# USTA AT LAKE NONA

## SUMMARY

**Applicant's Request:**

# MASTER PLAN ANALYSIS

# ROADWAY CROSS-SECTIONS—USTA BOULEVARD

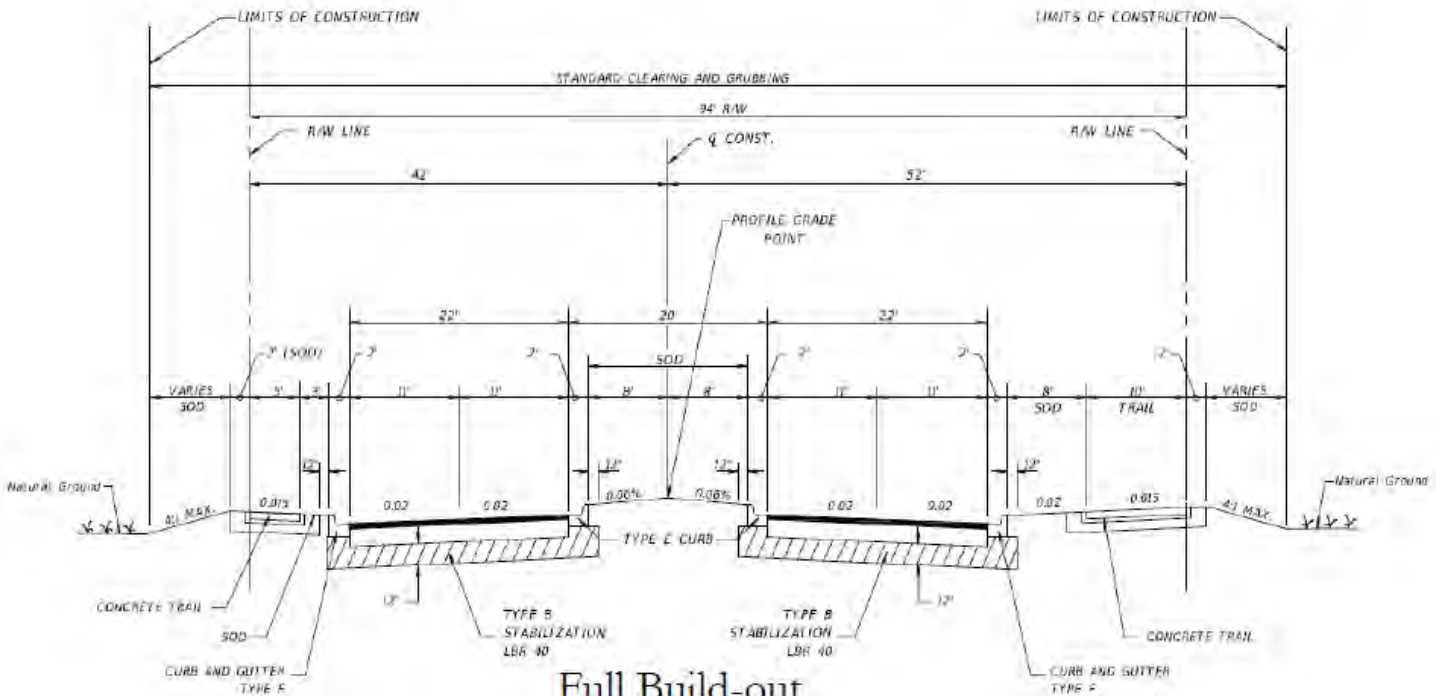
The full build out four lane cross section shall be revised as per the condition of the Transportation Planning staff.
